Urban Design Masterplan

- Road Network and Traffic Management Plan
- Road Safety Audit
- ESR Response

ROAD NETWORK PLAN HENDY MAIN ROAD MORIAC

Proposed Development

TYPICAL ROAD SECTION - 20m ROAD RESERVE

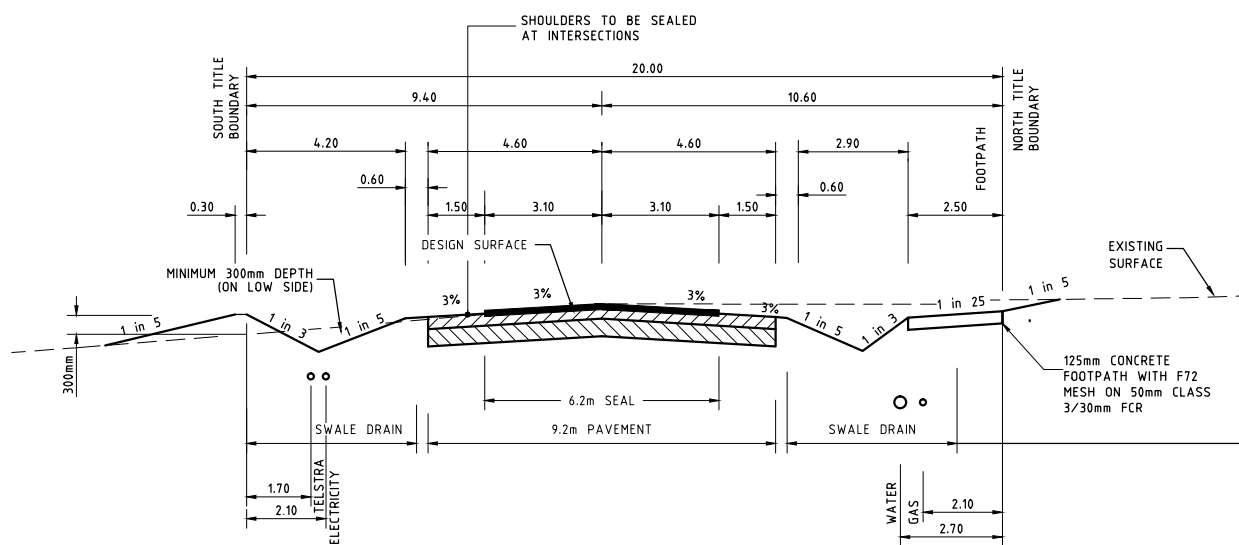
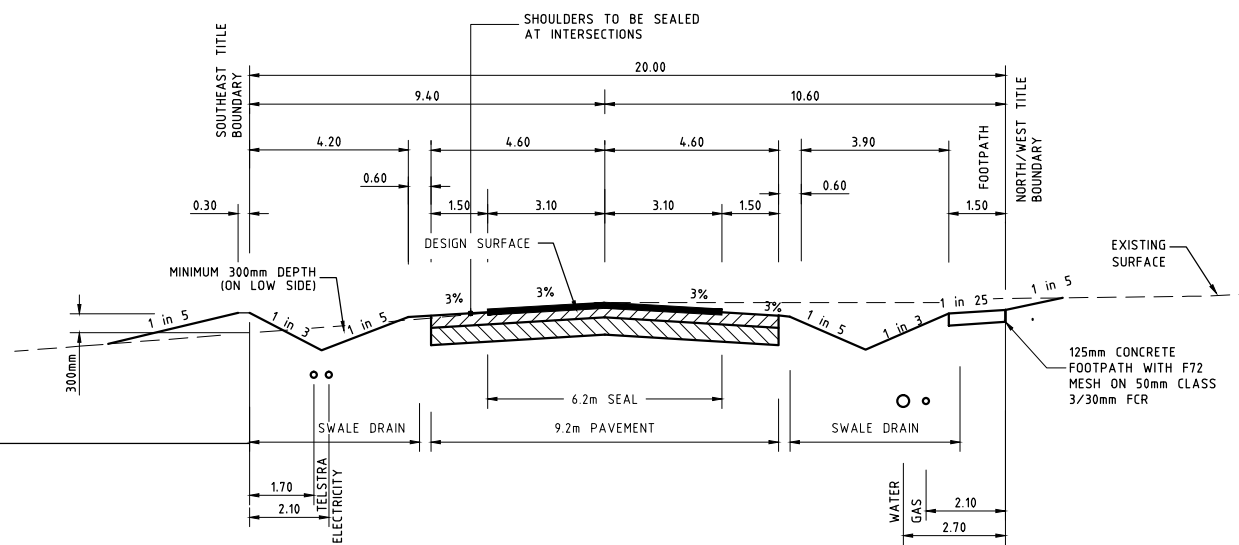
Audit Point	Comment / Suggestion	TGM Group Geelong	
			Response	Status
4.6.	Table Drain: The V drain fore slope and back slope combinations are not consistent with Austroads guide to road design Part 3.	Review proposed V drain fore slope and back slope.	Road cross sections are in accordance with Council's IDM standards

4.7.	Shared Use Path: The edge of the proposed 2.5m SUP along the eastern side of Hendy Main Road is hard up against the 3:1 back slope along the table drain. This arrangement is not consistent with current Austroads guidelines.	Ensure that a flat verge of at least 500mm is provided between the edge of the SUP and the table drain back slope.	Road cross sections are in accordance with Council's IDM standards	
Internal

4.8.	Lane width: 3.10m lanes with mostly unsealed shoulders (other than at intersections) may not be suitable within an estate that is likely to have a larger 85 th percentile vehicle than urban estates.	Review proposed sealed lane widths.	Road cross sections are in accordance with Council's IDM standards	
<p><i>This development consists of 51 allotments. They are very large allotments (ie: about 8 to 10 times the size of a normal residential allotment). Normally each allotment could generate up to 8 person trips per day (400 trips per day) all of which could be expected to be made by car (there are no public transport routes). Given the size of the allotments, occupiers might adopt uses that foster "hobby farm" activities (as long as this falls within the zoning of Low Density Residential development). The proposed cross sections of each connector to Hendy Main Road is 6.2 metres with sealed shoulders at intersections. Each of the connectors to Hendy Main Road are estimated to carry 200 trips per day. The two-lane carriageways as proposed should cope satisfactorily with these volumes, However, further consideration would need to be given to geometry at the two intersections at Hendy Main Road to cater for "Hobby Farm" type vehicles, commercial vehicles and emergency vehicle swept paths. Consider sealing Hendy Main Road across the front of the property development between the connectors.</i></p>

The plan provided was the general layout plan shown below (TGM Group Rev 2 dated 24/2/16).

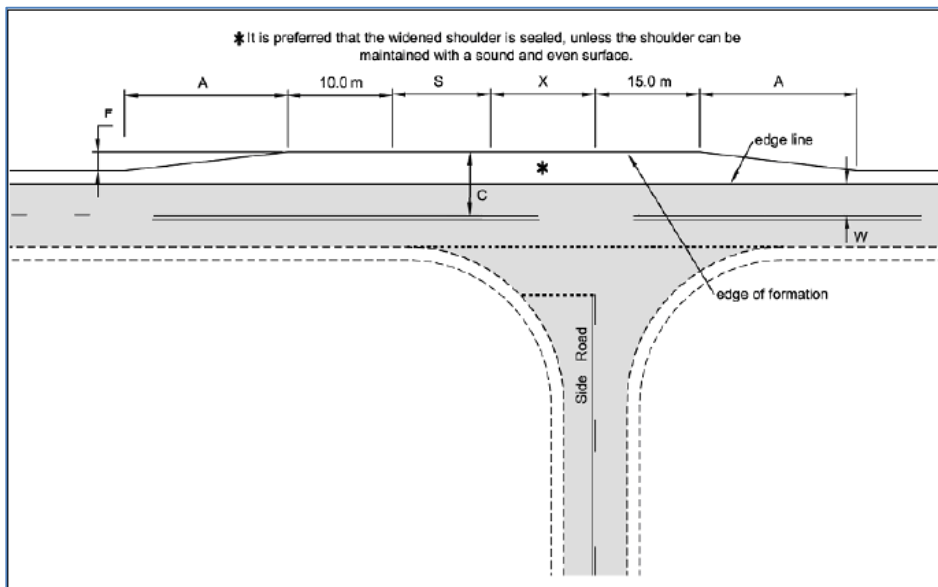
4.1.	<p>Intersections: Two basic intersections are proposed. These intersection types do not reduce driver speed on Hendy Main Road (as a roundabout does).</p> <p>Although this intersection type might be a reasonable choice at this location given the volumes and speed limit and allotment size, having two intersections rather than one essentially doubles the potential for conflict. It is acknowledged that the proposed basic intersection layouts are consistent with the treatments already present along Hendy Main Road.</p>	<p>Ideally the internal roads would come together to result in one intersection only. Consider if it would be possible to only have one intersection from the development, intersecting Hendy Main Road at a roundabout.</p> <p>Review feasibility.</p>	Disagree two roads required for fire safety purpose and better distribution of traffic ,low traffic volumes and speeds do not warrant a roundabout

Audit Point	Comment / Suggestion	TGM Group Geelong	
			Response	Status
4.2.	Intersections: There is a school, lodge and church in the vicinity of the proposed northern BA intersection. Similarly, there is a community centre at the southern intersection. Depending on the level of activity and turning movements at the existing abutting development at both proposed intersections, there may be an increased potential for conflict.	Take into consideration the turning movement activity generated by the abutting development and how it will conflict with the turning movements at the two proposed intersections. The roundabout option as suggested in point 4.1 could eliminate conflict with movements due to existing developments at the northern and southern ends,	Not considered appropriate as traffic volumes are very low ESR have confirmed that they are satisfied with the design.

4.3.	Spatial design: Although 'residential', lot sizes are 4000-5000m ² . It should be expected that trucks will feature prominently in this estate due to hobby farms and blue-collar employment.	Ensure the design vehicle is chosen carefully and that the intersection layout allows for this design vehicle. It should be noted that the widths at Deppeler Ave are considered to be too narrow to facilitate truck movement and should not be adopted at the proposed intersections if truck use is expected.	Proposed Road standards can facilitate truck movements also lots from 4000 to 5000m ² will not typically support farming practices requiring trucks

4.4.	Shoulders: Existing shoulders appear to be in poor condition. 	It is expected that shoulders will be fixed as part of the proposed BA treatments at the two intersections.	Agree

4.5.	Line marking: The line marking shown in figure 7.5 of Austroads Part 4A for BA is probably superseded by VicRoads standard markings.	Ensure further design incorporates the latest line marking details.	Will be guided by Vic Roads

4.9.	Horizontal alignment: The 60-degree kinks in the road have no radius.	It is expected that appropriate curve radius and cross fall will be provided at later stages of the design. However, appropriate land reservation should be set aside not to ensure a suitable curve can be provided.	Agree

4.10.	Linear Park: Is the Barwon Water reserve (long green line shown in the drawing supplied) a linear park which will be accessed by residents or just an unpopulated floodway? If it is accessible by residents, there is no indication of access and crossing arrangements at the park/road intersections.	Review.	Will be gated
